SIBLING
ARCHITECTURE

OLD BEGA HOSPITAL
ARTS & CULTURAL CENTRE

DESIGN DEVELOPMENT 03
30.04.2018

1. REVIEW OF FEEDBACK ITEMS

SHED POSITION OPTION 1

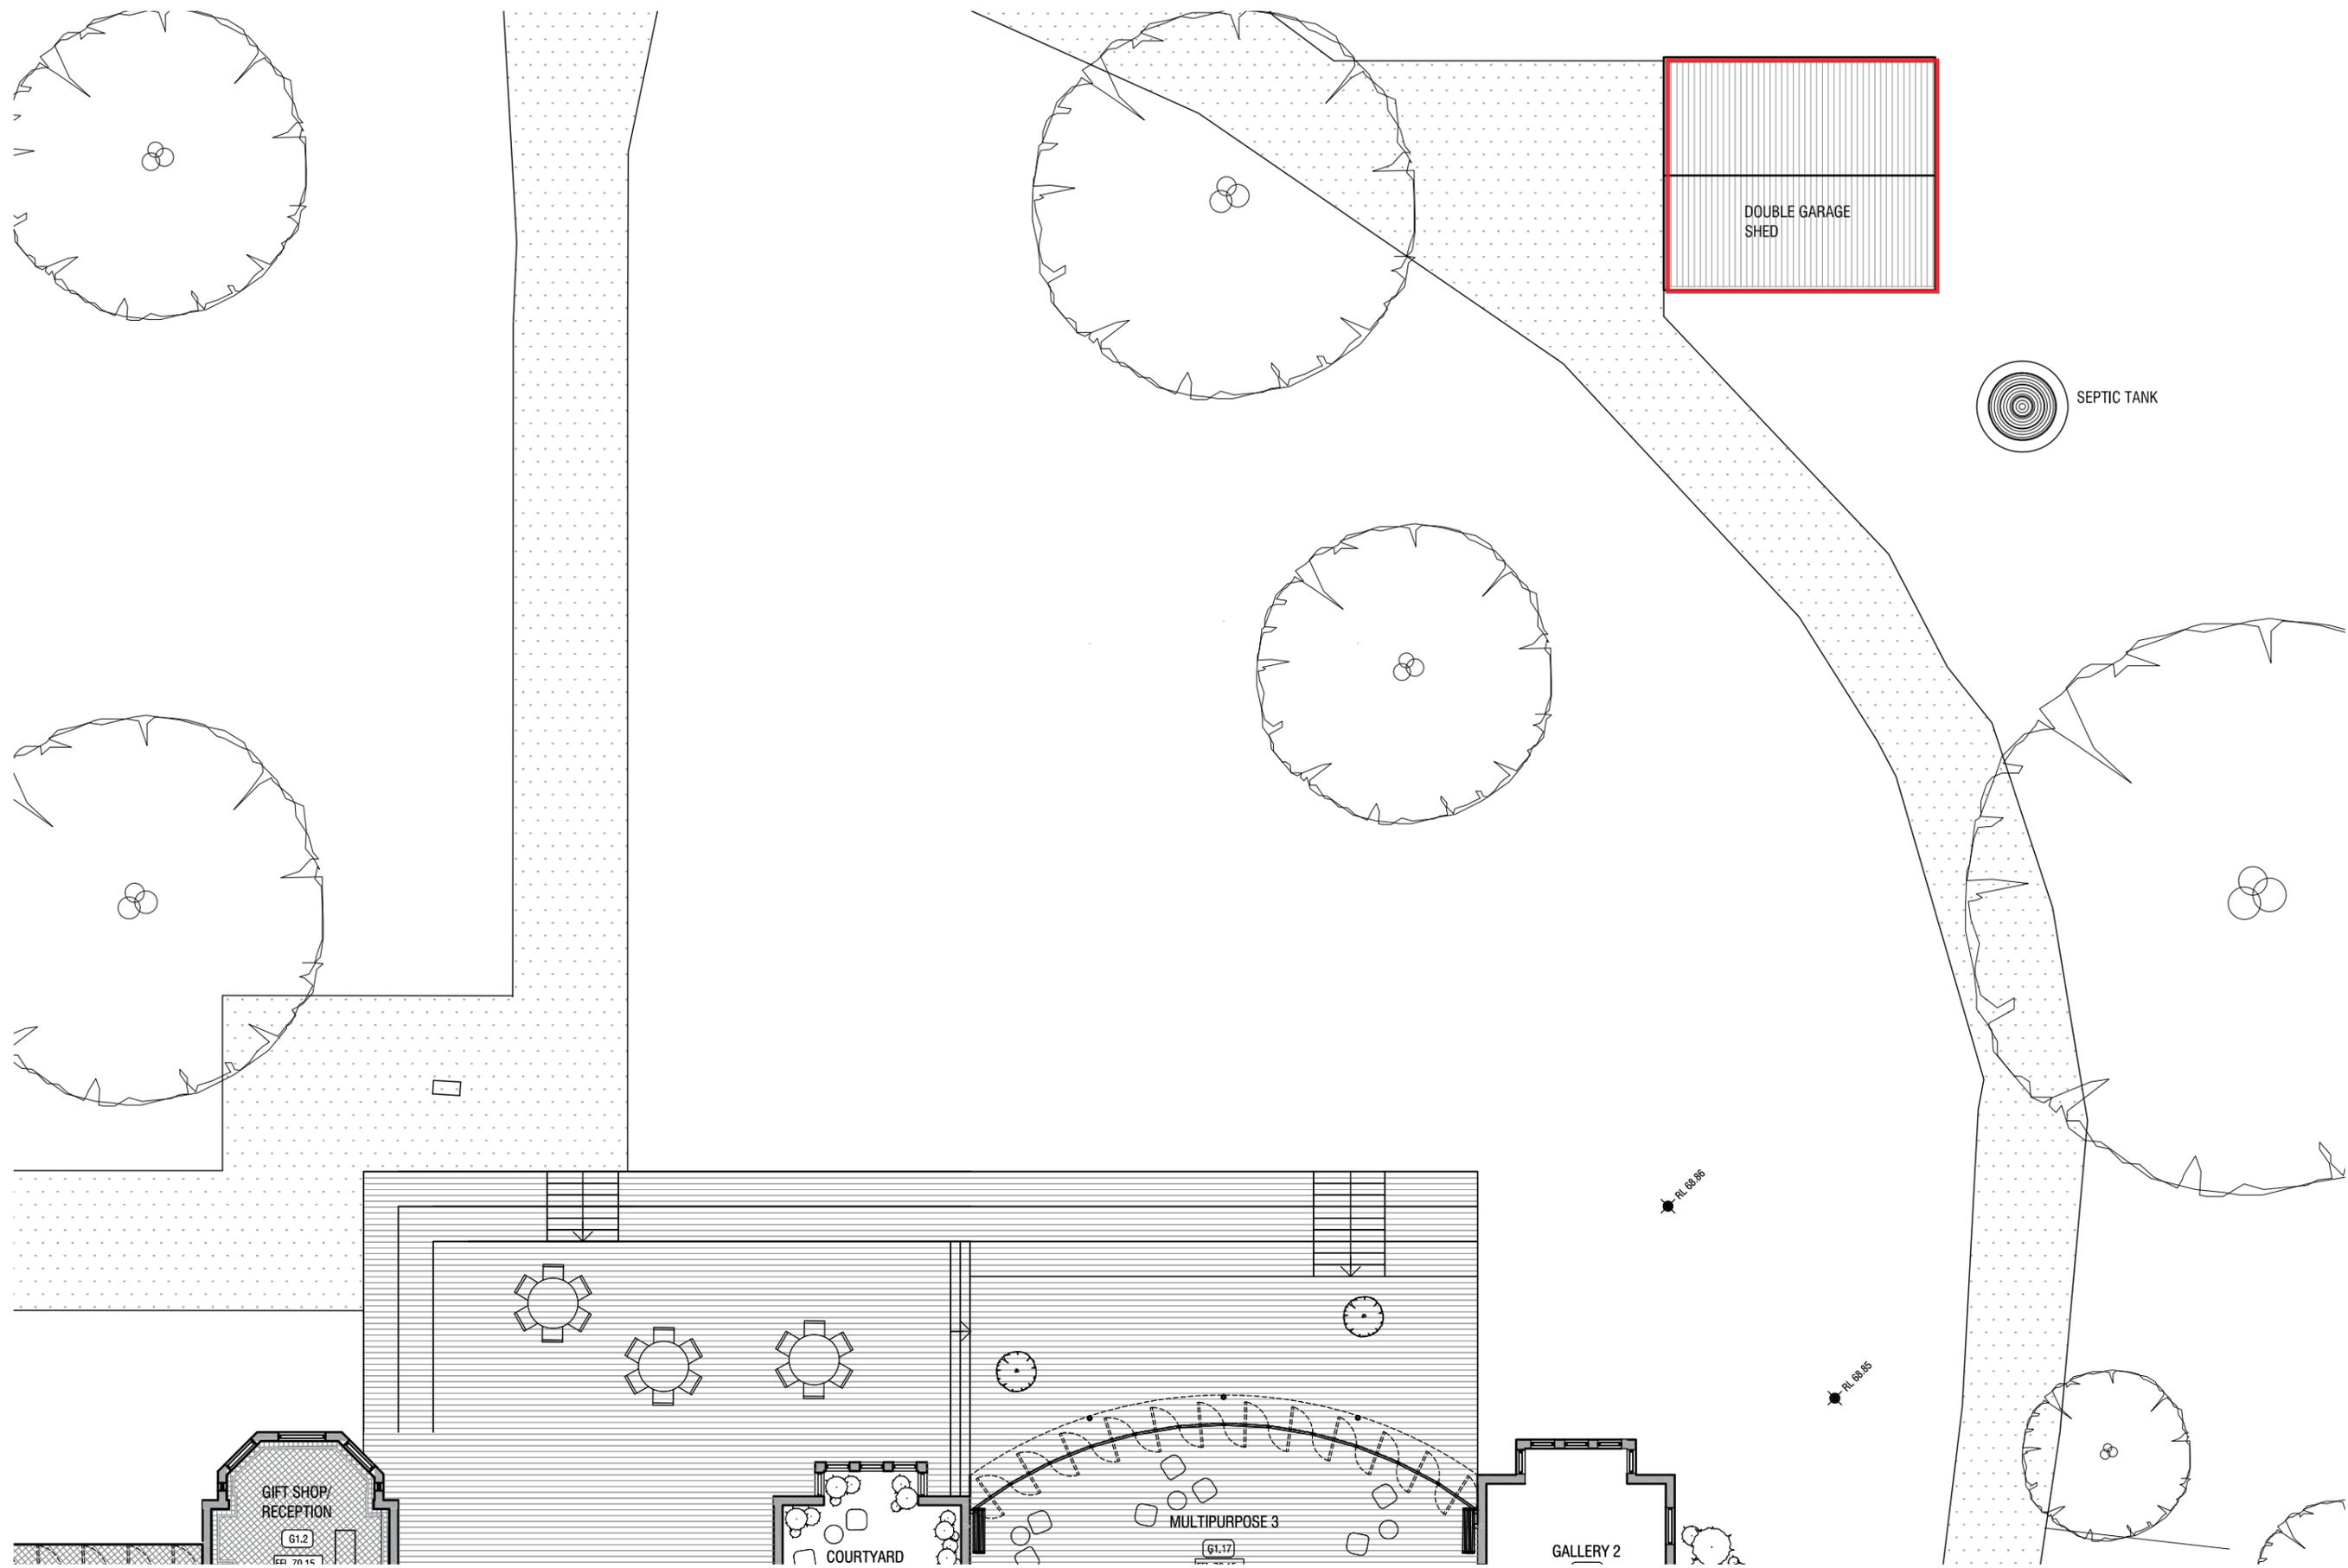
6. TRUST NEEDS A LOCATION FOR GARDEN EQUIPMENT AND THE LIKE. DOUBLE GARAGE SIZED- SEE OPTIONS FOR GARAGE POSITIONING ON FOLLOWING PAGES
